Old Orchard, Monaleen, Co.Limerick

Modification of the Large-Scale Residential Development at Monaleen, Co. Limerick

Stage 2 Road Safety Audit

May 2026

Figure 2.1

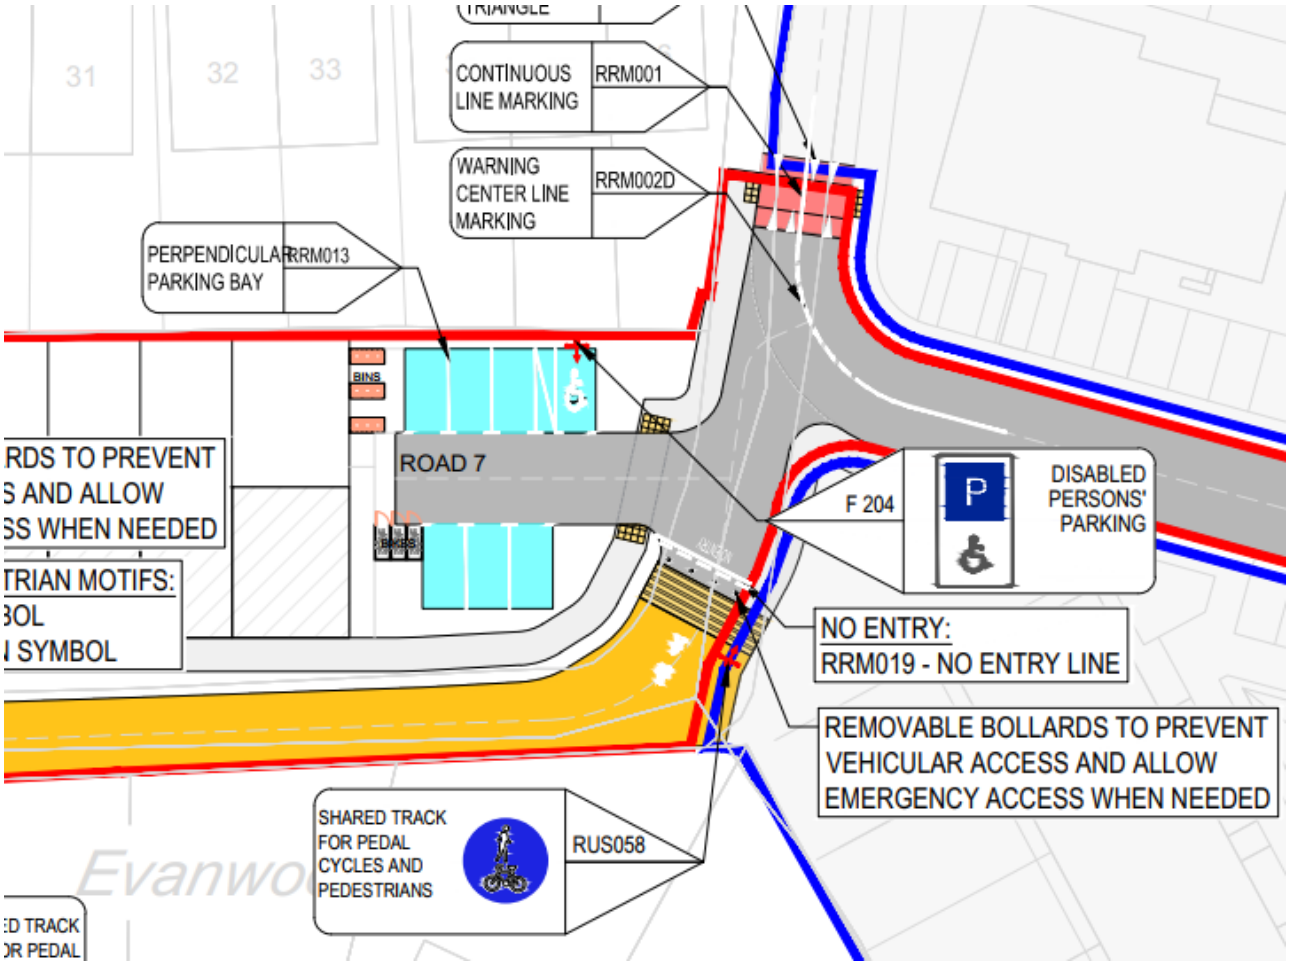
2.1. PROBLEM 1: JUNCTION ARRANGEMENT BETWEEN ROAD 7 AND SHARED SURFACE

The drawings show a shared surface (pedestrain & Cyclsist) between the Main housing development and the creche entrance from Golf Links Road. As the creche is located here, the Audit Team belive that parents will use this route to walk and scoot directly with children too and from the creche. The design team should review the junction arrangement at the location to give more protection to Vulnerable road users as they transition form the shared surface to and from the housing development. A lack of clarity and/or tighting of the junction at this location, could result in vehicles being parked in an ahoc nature here.

Recommendation 1

The design team should review the junction arrangement at this location and ensure the protection of VRU's is prioritised.

Figure 2.2

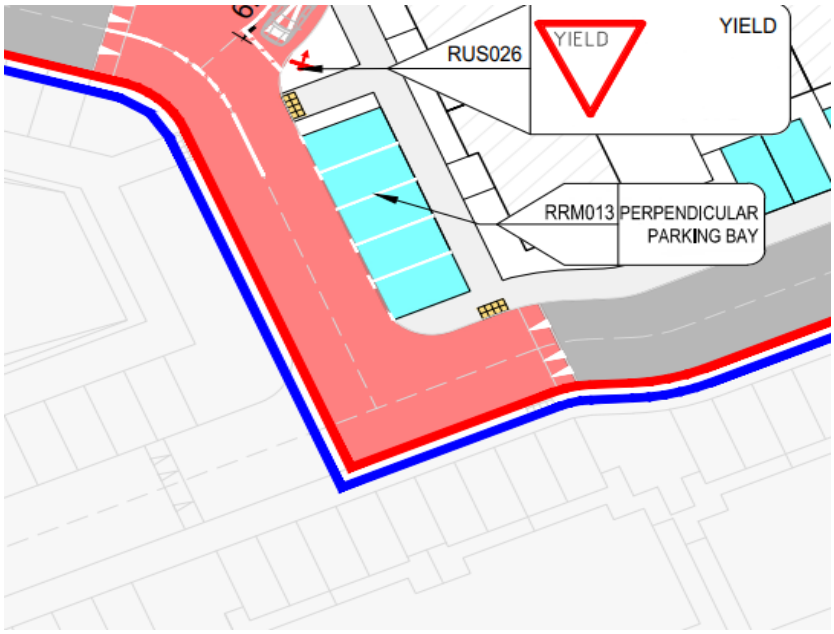
2.2. PROBLEM 2: JUNCTION PRIORITY

The drawings provided to the audit team does not show the junction priority on the south western corner of the site (refer to Fig 2.2). A lack of clarity over priority at the location could lead head-on type collision between vehicles approaching from different direction.

Recommendation 2
The design team should clarify who has priority at this junction and update with the relevant signing and lining arrangement.

Figure 2.3

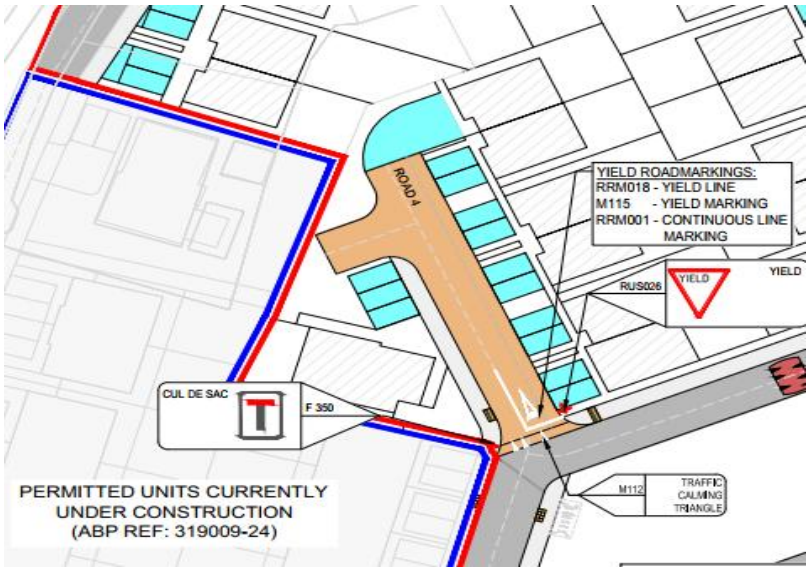
2.3. PROBLEM 3: SHARED SURFACE AT ROAD 4

It appears from the drawing issued that Riad 4 is proposed to be Shared surface with a pedestrian refuge along the western side. The drawing issued, do not show the proposed width of these facilities. The drawing appear to show a contract in surfacing which is in line with DMURS. An unnecessary road width at this location will encourage cars to drive at an excessive speed and could result in collision with vulnerable road users.

Recommendation 3
The design team should confirm that this section of the road is line with the relevant standards.

Figure 2.4

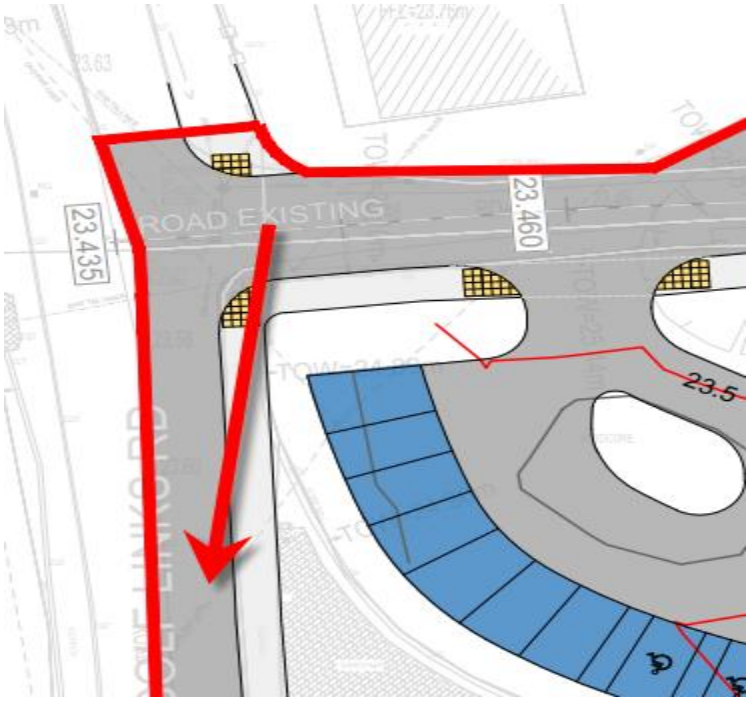
2.4. PROBLEM 4: SIGHTLINES AT CRESH EXIT ONTO GOLF LINKS ROAD

The Audit team observed that sightlines are currently restricted at the proposed exit from the creche onto Golf Links Road. It is unclear from the drawings if these are to be improved or not. Inadequate sightlines could lead to side impact type collisions between vehicles exiting on Golf Links road and vehicles travelling along the main road.

Recommendation 4
The design team should ensure that the adequate sightlines are provided in accordance with the relevant standards.
